TRANS/WP.29/GRSP/2004/6/Corr.1
19 March 2004

World Forum for Harmonization of Vehicle Regulations (WP.29)

PROPOSAL FOR DRAFT AMENDMENTS TO REGULATION No. 44
(Child restraints)

Corrigendum 1

"Annex 14

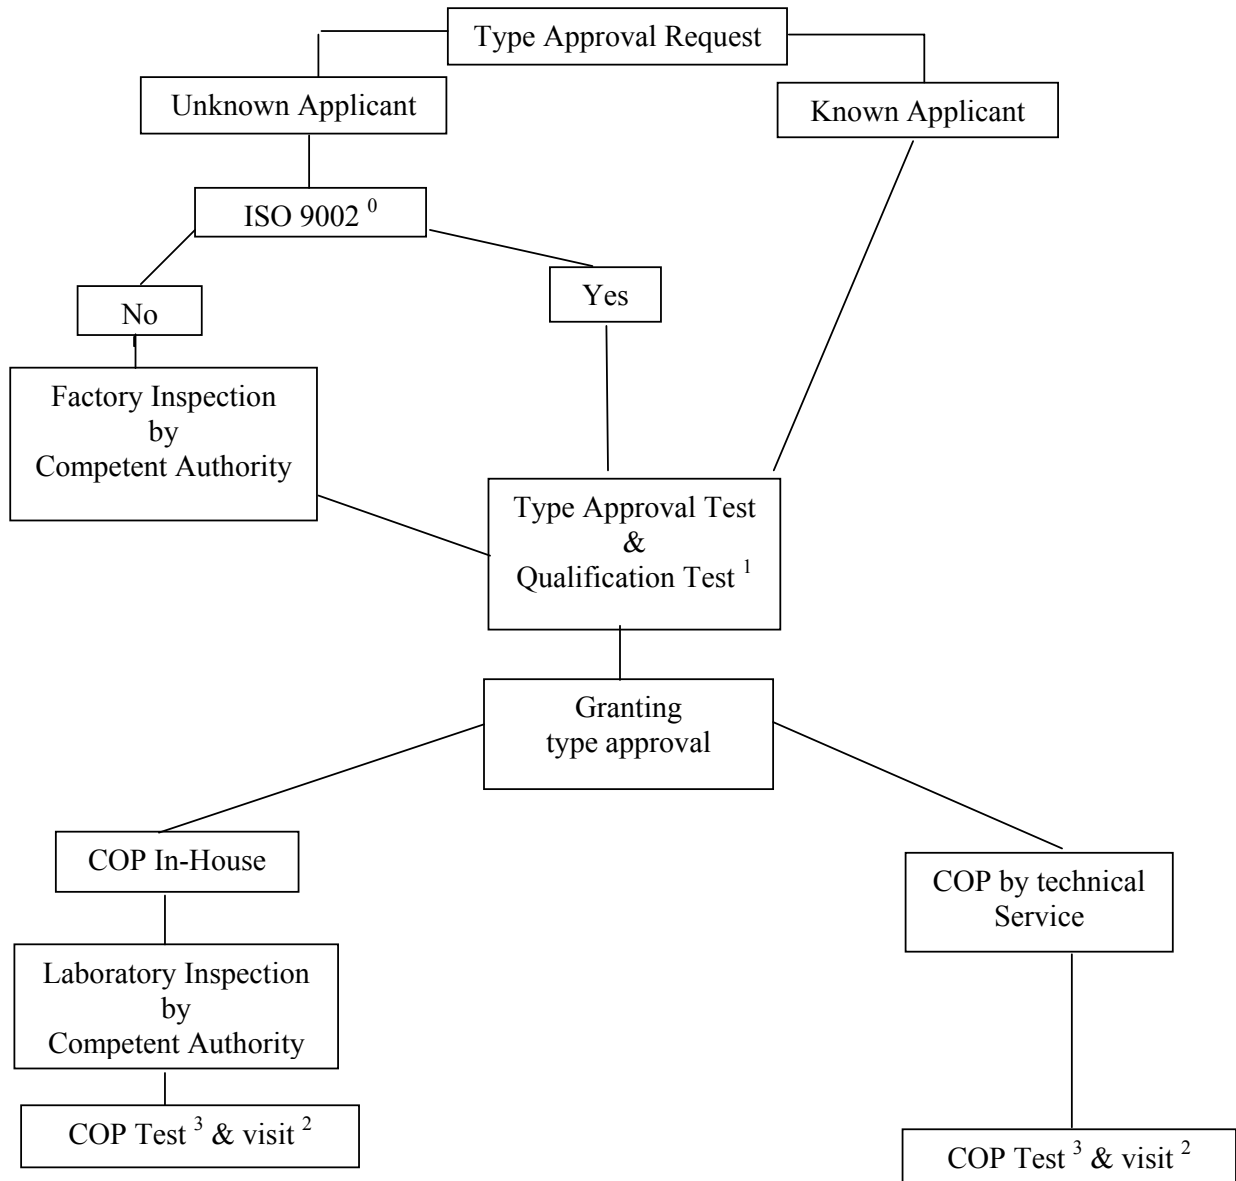
Inserted new annex 14, correct to read:

- 0) or an equivalent standard to this one
- 1) these tests shall be done by technical service
- 2) visit to the manufacturer for inspection and random sampling by the Authority or technical service
 - a) if there is no ISO 9002: 2 times a year
 - b) if there is an ISO 9002: 1 times a year
- 3) tests in accordance with annex 16
 - a) if there is no ISO 9002:
 - i. of the Authority or technical service during the visit of footnote 2a
 - ii. of the manufacturer between the visits of footnote 2b
 - b) if there is an ISO 9002: taken by the manufacturer, procedure checked during visit of footnote 2b. "
